# Port Kembla Gas Terminal Submissions Report

February 2019

## 1.2 Purpose and structure

**Figure 4-2 Near bed temperature impact – Autumn (no BlueScope discharge)**

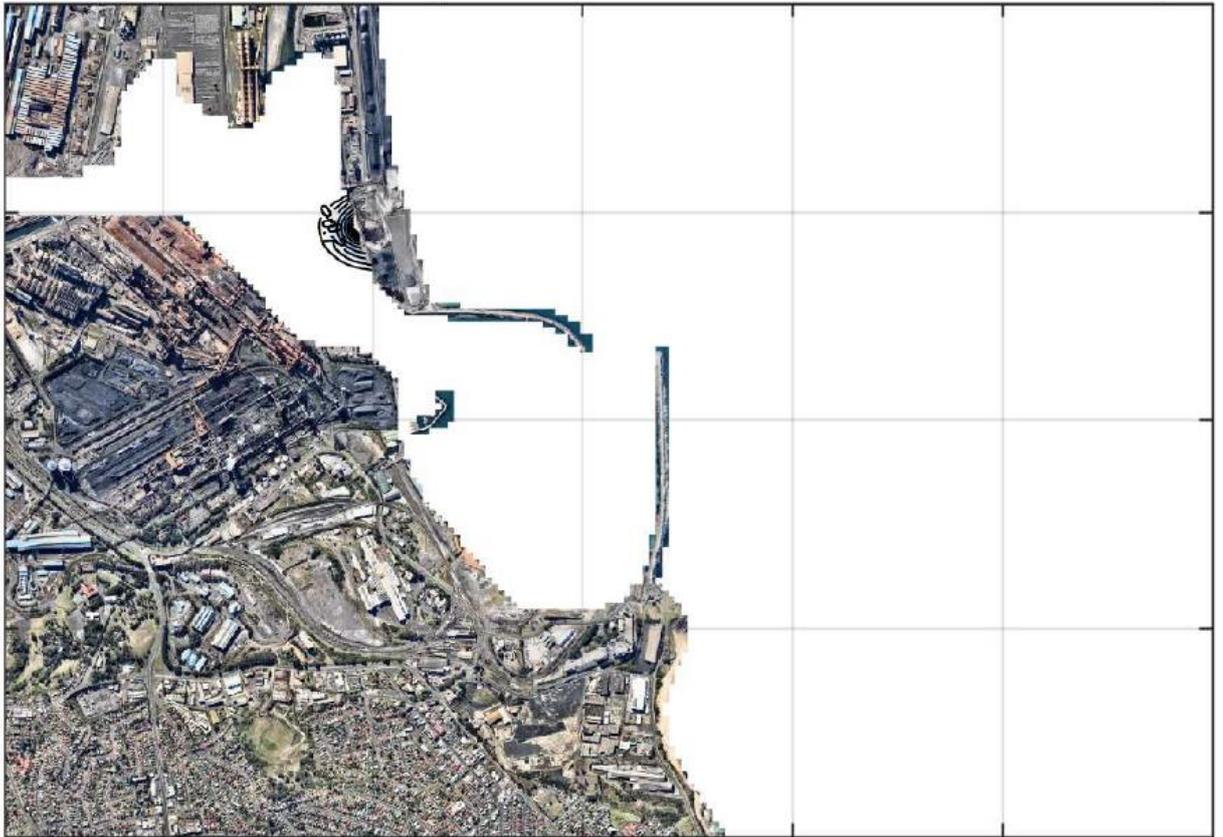
<p><b>Chlorine discharge criteria</b></p> <p>The submission queries the assessment and adoption of the appropriate criteria to assess the levels of chlorine discharge and other by-products from the marine growth protection system during operation of the FSRU.</p> <p>The submission states that the use of the adopted criterion from the IFC World Bank Guidelines for chlorine of 200 micrograms per litre was not appropriate for assessing potential environmental impacts. It stated the assessment should be revised to align with the adopted NSW water quality objectives that align with the Australian and New Zealand Environment and Conservation Council water quality guidelines.</p> <p>It also makes reference to the US EPA guidance for acute risk to marine waters at 13 micrograms per litre and chronic risk at 7.5 micrograms per litre. It notes that a discharge at 200 micrograms per litre would be significantly above those criteria at the point of release.</p>	<p>Section 4.2.1</p>

Plots showing the extent of the non-complying cases are presented in Figure 4-1 and Figure 4-2 comparing the 50th percentile temperature from the FSRU only (i.e. no BlueScope discharge) simulations to the 20th Percentile ambient conditions. Areas shown in blue are colder than the 20th percentile ambient temperatures and are therefore colder than the allowable limits specified in the ANZECC guidelines. From examination of the plots it is apparent that the area predicted to be colder than the allowable limits specified in the ANZECC guidelines is restricted to an area measuring approximately 50m by 100m immediately adjacent to the FSRU. Given that the nearfield mixing zone is predicted to have a radius of up to 42.5m (diameter of approximately 85m area), the predicted zone of non-compliance is considered to be approximately within the nearfield zone given that the far field model resolution is in the order of 30m. For completeness, a plot representing the complying cases for all complying scenarios is presented in Figure 4-3.

**Figure 4-5 Staging of berth dredging and construction**

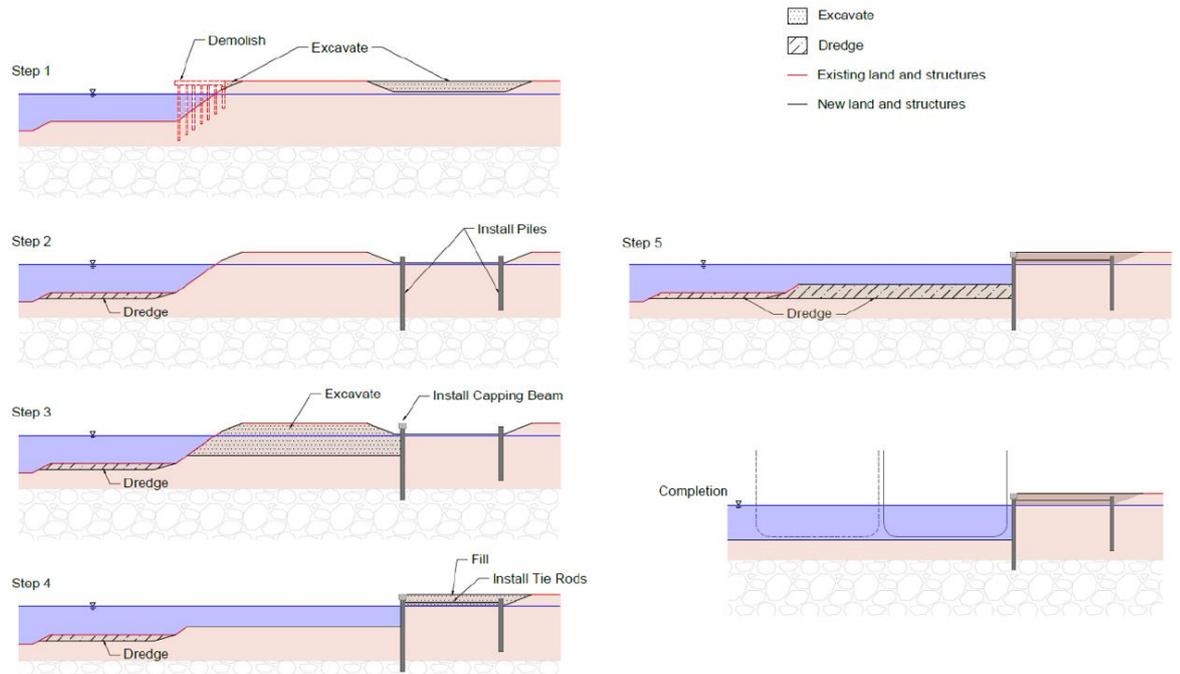
Government agency	Comment/issue	Section reference
	<p><b>Excavation and dredging</b></p> <p>The submissions sought further information on the staging of excavation, dredging and disposal, including the balance of material to be hauled by truck or transported by barge.</p>	Section 4.2.3
	<p><b>Port Kembla Outer Harbour Development</b></p> <p>The submission stated that the proponent should confirm that dredged and excavation material to be disposed in the disposal area would be compatible with the planned Port Kembla Outer Harbour Development. It noted the potential for the concept plan for the Port Kembla Outer Harbour Development to change with the potential for sediments to be disturbed again.</p>	Section 4.2.3
	<p><b>Disposal alternatives</b></p> <p>The submission stated that alternative options to disposal in the disposal area should be considered including options to remove contaminations from Port Kembla as a permanent solution, the use of Commonwealth sea dumping permits, offsite treatment or offsite disposal.</p>	Section 4.2.3

Prior to dredging of contaminated sediments from Berth 101, the Contractor will first commence demolition of the existing wharf and excavation of the Berth 101 landside material (shown to contain relatively minor levels of contamination). This material will be removed using land based plant and equipment before being loaded onto barges for transport to the Outer Harbour. The material will be re-used by bottom dumping from the hopper barges to construct the Outer Harbour perimeter bunds, which will prevent the slumping of the contaminated sediments to be dredged within the upper portion of the existing Berth 101 area. Bunds will be formed using fill and compacted hardstand material, These bunds will be designed and constructed in accordance with the existing Containment Structures and Emplacement Report prepared in 2015 on behalf of NSW Ports for the Berth 103 Stage 2 Dredging Project. Where necessary the design will be customised during the detailed design phase to suit any different material types associated with materials present at Berth 101 or to take advantage of any innovative techniques that offer improved outcomes. Figure 4-5 and Figure 4-6 show indicative staging diagrams for construction of the proposed Inner Harbour berth and Outer Harbour bunds.

**Figure 4-7: Schematic showing final emplacement of sediments at the emplacement area**

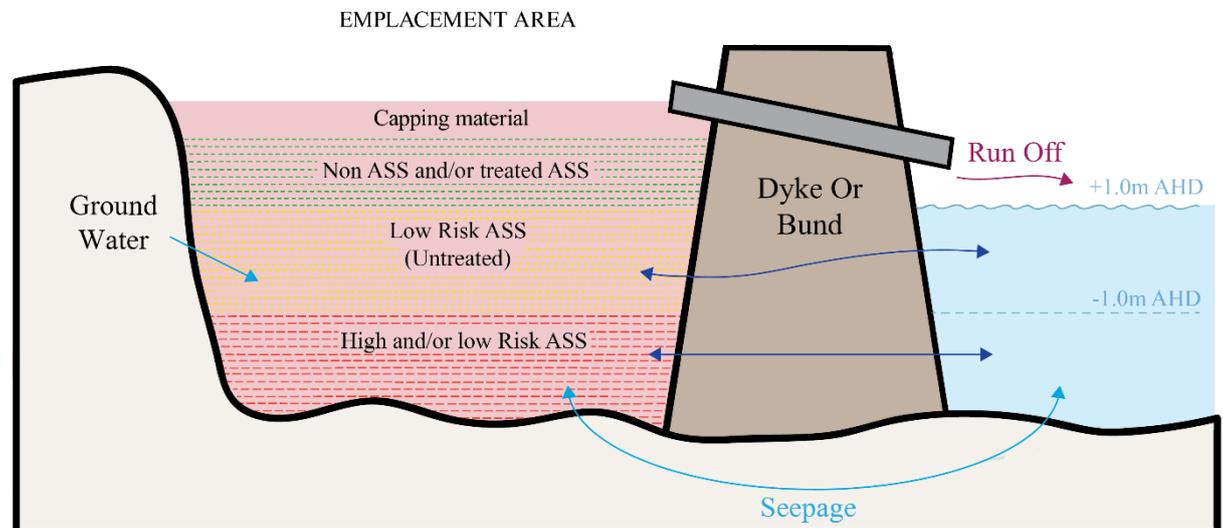
Government agency	Comment/issue	Section reference
	<p><b>Bund material</b></p> <p>The submission stated that slag and dredged material from the Inner Harbour may have been used in the original construction of Berth 101 and may be contaminated. It noted that sampling referred to in the EIS found relatively minor contamination. It stated the potential impacts of the use of that material for bund construction in the Outer Harbour was not adequately assessed.</p> <p>The submission stated additional information should be provided on the suitability of excavated and dredged material for bund construction in the Outer Harbour, including:</p> <ul style="list-style-type: none"> <li>• acceptability of contaminant level and potential for contaminant hot spots</li> <li>• potential for acute or chronic toxicity including colonisation by marine life</li> <li>• measures to ensure material found to have elevated contaminants including dioxin, benzo(a)pyrene or hydrocarbons are not used for bund construction</li> <li>• the need for stabilisation of contaminants in bund material to minimise potential leaching of contaminants or to neutralise potentially acid forming material</li> </ul>	Section 4.2.3

- Low risk ASS (Units 1A and 1B) will be placed within an anoxic environment within 48 hours of excavation and/or dredging or may be temporarily stockpiled. Where stockpiling exceeds 2 days these sediments will require daily pH monitoring using the field peroxide test (as per ASSMAC 1998 Appendix 1). Where stockpiling exceeds two weeks these sediments may require neutralisation with lime depending on the results of monitoring. These sediments show high concentrations of shell grit which may provide sufficient self neutralising capacity making liming unnecessary. Further testing would be required to confirm or otherwise the capacity for self neutralisation in the low risk ASS.

Figure 4-7 below shows the intended burial sequencing of the sediments at the emplacement area.
